The New Service Bulletin **Look!!!** All Future Product Service Bulletins Will Be On White Paper . . . Easier To Read . . . Clearer Photographs and Illustrations. . . Product Identification At TOP of Bulletin For Easy Filing.

- A. Battery Installation/Outboard Powered Aluminum Boats
- B. Quicksilver Tachometer/RPM Indicator
- C. Bearing Carrier Lube Fittings - New 80/90/ 115 HP Models
- D. Engine Installaiton - New 50/70 HP Models

Figure 2. Tool Modification

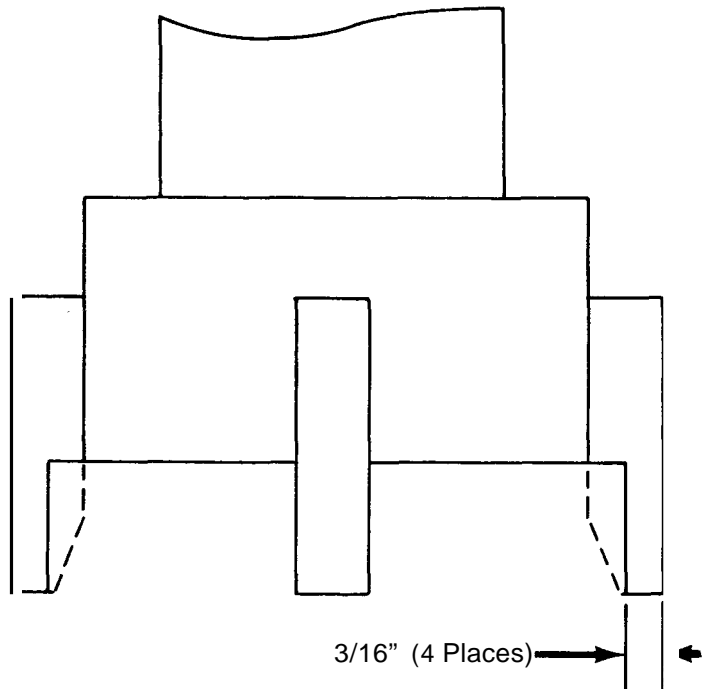
The older Gear Housing Cover Tool P/N 91-73688 will strike on the outer lubrication fitting. The tool must be modified by machining the inside diameter, as shown in Figure 2 (or, a new, modified tool, 91-73688 may be purchased).

Figure 3. Installing Engine on Transom

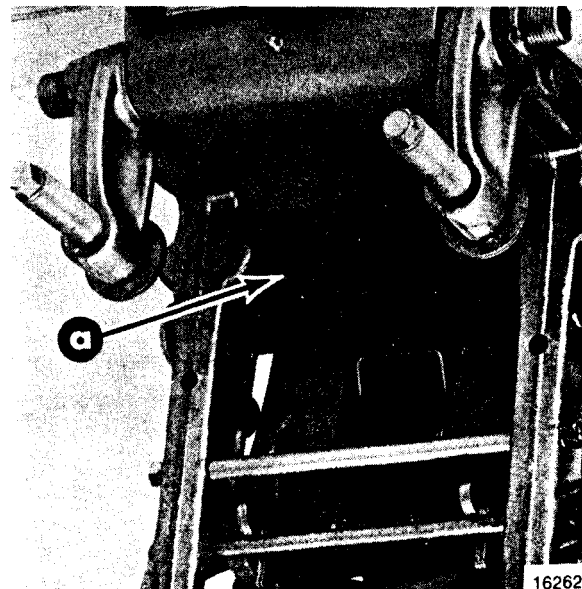
The shock absorbers are no longer standard equipment on new 50/70 HP models. They have been replaced with a nylon strap. When installing these outboards on the boat transom. **MAKE CERTAIN** that the nylon strap is not caught between engine and top of boat transom. (Figure 3)

*NOTE: Power Trim Installation Kit, P/N 62538A3 now contains the installation pins that were previously standard when the shock absorbers were on the outboard.*
